CANADIAN PATENT APPLICATION NO. 2,256,944

IMPROVED VEHICLE

Title: SNOWMOBILE

Application No		Applicant(s)
		09/472,134		GIROUARD ET AL.
	Office Action Summary	Examiner		Art Unit
		Anne Marie M	Boehler	3611
	The MAILING DATE of this communication	on appears on the cov	er sheet with the c	orrespondence address
THE II - Exter after - If the - If NO - Failu - Any r earns	ORTENED STATUTORY PERIOD FOR F MAILING DATE OF THIS COMMUNICAT sisten of time may be available under the provisions of 37 southern the provisions of 37 southern the provisions of 37 southern the provision of 37 southern the form the mailing date of this communication of or reply specified above, the maximum statutory reproduced for reply is specified above, the maximum statutory to reply with the act or extended period for reply will, by epily received by the Office later than the other than the property of the office later than the other than the property of the office later than the office of the other than the	CFR 1.136(a). In no event, ho tion. s, a reply within the statutory r period will apply and will expi	wever, may a reply be tin minimum of thirty (30) day re SIX (6) MONTHS from	nely filed ys will be consid

PTB Enclosures: Figs. 2 and 3

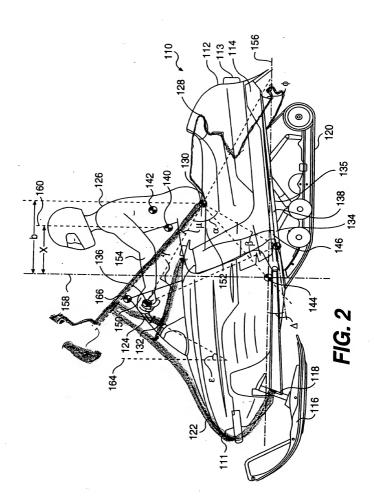
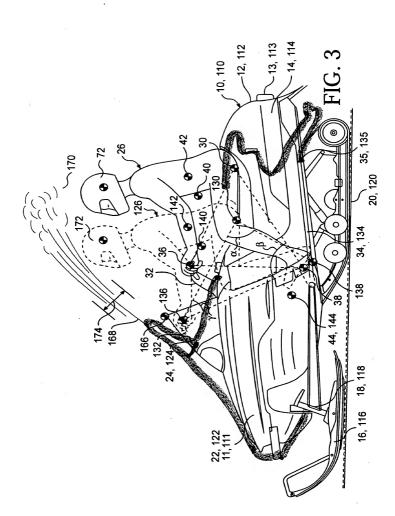
- 1. The corrected or substitute drawings were received on May 22, 2002. These drawings are not approved by the examiner because they contain new matter. The windshield configuration, in particular, is not supported by the original disclosure. These changes do not make the drawings more consistent with modified Figure 4, as indicated in applicant's remarks, and they significantly alter the position of the windshield, including the position of the windshield top edge relative to the steering member (the angle formed between the windshield, seat position, and steering member, recited on pages 13 and 14), which is a claimed feature of applicant's invention and which is described in applicant's detailed disclosure.

Applicant fails to show an operative embodiment of the invention. The only drawings of applicant's invention are Figures 2 and 3, which show the snowmobile with a rider in the prior art position and in the position he would assume if riding on applicant's snowmobile. The main difference between the two snowmobiles (the prior art one and that of the applicants) is the position of the handlebars. However, the positioning of the handlebars in Figures 2 and 3 would not allow any significant steering of the vehicle. Therefore, applicant's invention, as disclosed, is inoperative.

Applicants submit herewith proposed corrections in red to Figs. 2 and 3. Approval of the proposed changes is respectfully requested.

PTB/jck Attachment: Figures 2 and 3

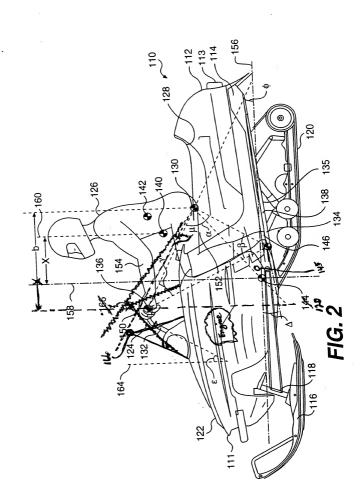
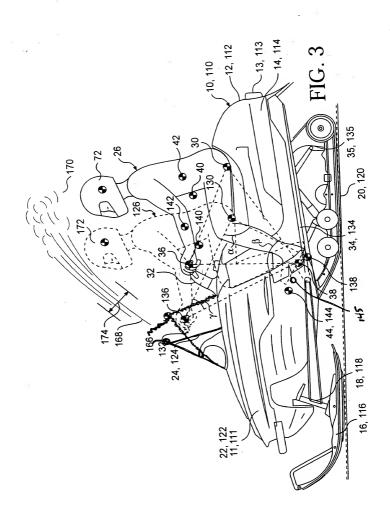
- Proposed drawing changes have been approved, however, even as amended, the drawings
 do not show the handlebars in a position which would allow any substantial amount of movement,
 as would be required to steer the vehicle.
- 2. Claims 1-49, 55, 57-61, 64-68, 73, 76-84 are rejected under 35 U.S.C. 112, first paragraph, as containing subject matter which was not described in the specification in such a way as to enable one skilled in the art to which it pertains, or with which it is most nearly connected, to make and/or use the invention.

Applicant fails to show an operative embodiment of the invention. The only drawings of applicant's invention are Figures 2 and 3, which show the snowmobile with a rider in the prior art position and in the position he would assume if riding on applicant's snowmobile. The difference between the two snowmobiles (the prior art one and that of applicant) is the position of the handlebars. However, the positioning of the handlebar in Figures 2 and 3 would not allow any significant steering of the vehicle. Therefore, applicant's invention, as disclosed, is inoperative.

Authorization is hereby requested to amend Figures 2 and 3 as indicated in red on the attached sheet. Approval of this change is respectfully requested.
